Re: Limerick Generating Station Units 1 and 2  
Docket Nos. 50-352 and 50-353

LIMERICK GENERATING STATION  
PROBABILISTIC RISK ASSESSMENT

The attached pages and divider are to be inserted at the end of Volume I of the Limerick Generating Station Probabilistic Risk Assessment report.

Figure 720.2-5

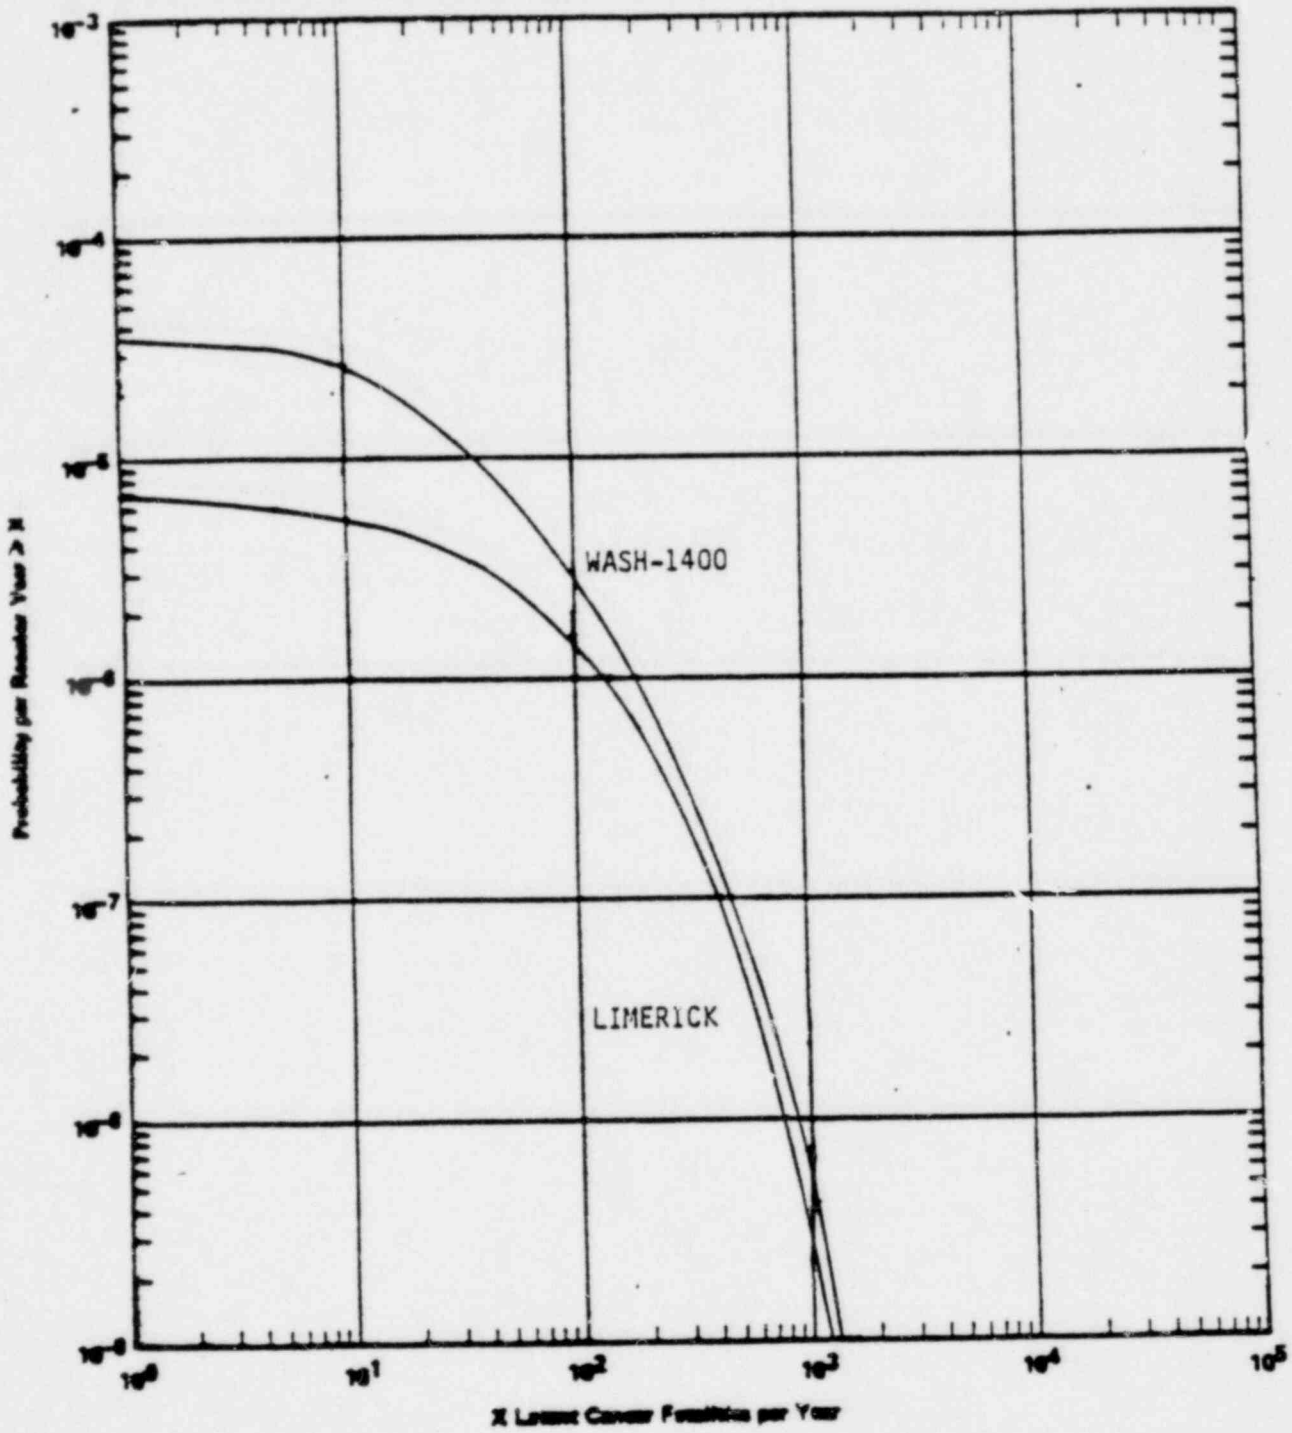
Sensitivity studies for latent cancer and property damage are needed to allow comparison with WASH 1400 results based on design and site differences only.

Sensitivity information on latent cancer is shown on the attached figures. The information on property damage will be supplied during the fourth quarter of 1981.
